HOWARD COUNTY HISTORIC PRESERVATION COMMISSION  
ELLICOTT CITY HISTORIC DISTRICT ■ LAWYERS HILL HISTORIC DISTRICT  
3430 Court House Drive ■ Ellicott City, Maryland 21043

## Agenda

**HPC-20-83 – 8049, 8055, 8059, 8061 (Tiber Park) and 8069 Main Street; Vicinity of Maryland Avenue and Main Street; Vicinity of 3711 Maryland Avenue along Patapsco River, Ellicott City – continued from December 3, 2020; January 14, 2021 and February 11, 2021**

**Request:** The Applicant, Robert Z. Hollenbeck on behalf of the Howard County Department of Public Works, requests a Certificate of Approval for the demolition of buildings at 8049, 8055, 8059, and 8069 Main Street, the demolition of a bridge at 8061 Main Street (Tiber Park); and alterations in the Vicinity of Maryland Avenue and Main Street, Vicinity of 3711 Maryland Avenue along Patapsco River, Ellicott City for construction of an enhanced floodplain and culvert.

Figure 12 - Existing conditions and proposed culvert.

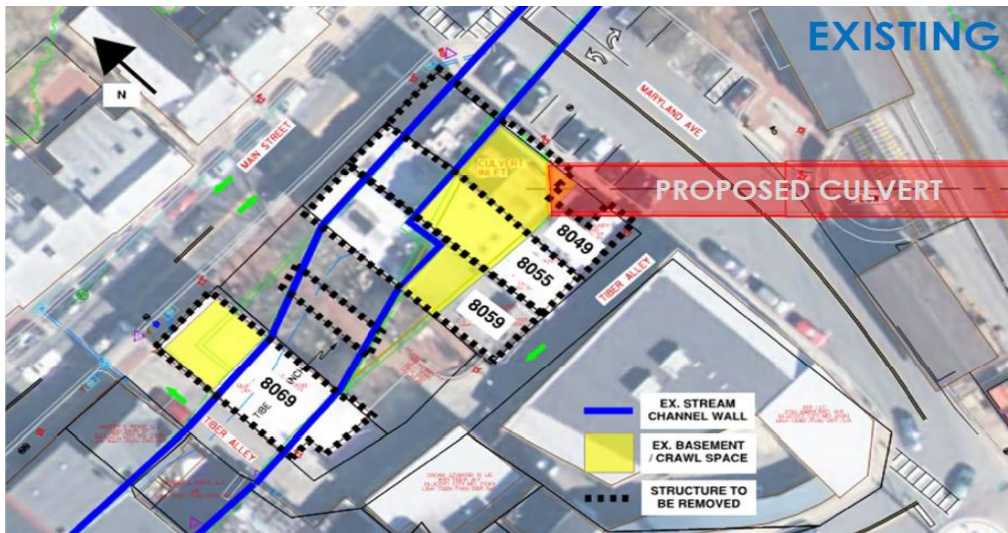
Slide 16 from Attachment A in the Applicant’s submission shows the existing stream channel with the location of the proposed culvert:

Figure 13 - Proposed terraced floodplain/culvert/expanded stream channel.

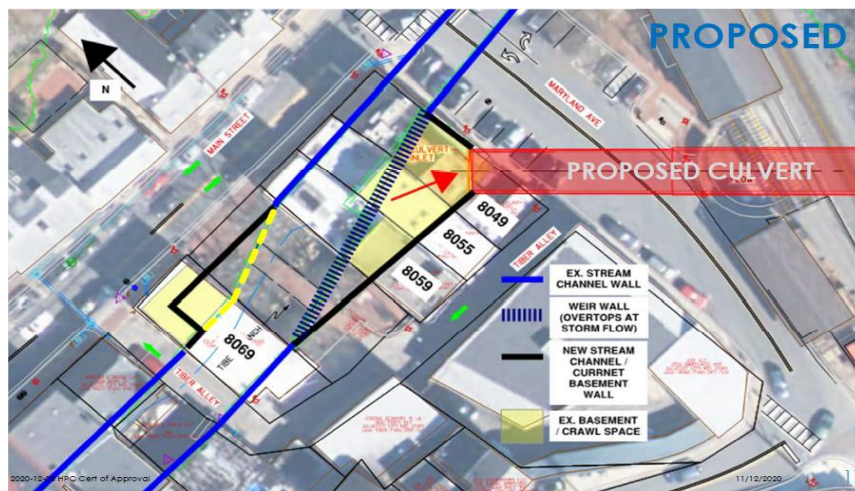
Slide 17 below from Attachment A in the Applicant’s submission shows the proposed stream channel with the proposed culvert and new terraced floodplain/new stream channel. The Applicant seeks approval for the construction of the expanded terraced floodplain/culvert/new stream channel as outlined in Items 6 and 7.

- 6) For HPC-20-83f, the construction of expanded terraced floodplain/culvert and associated components:
    - a. Staff recommends the Commission determine if there is sufficient detail to approve at this time, and whether or not the application complies with the Guidelines and §16.607 approve, deny or continue accordingly. Staff recommends that the Commission determine whether the proposed demolition and new construction comply with the Guidelines and §16.607 and §16.608 of the County Code.
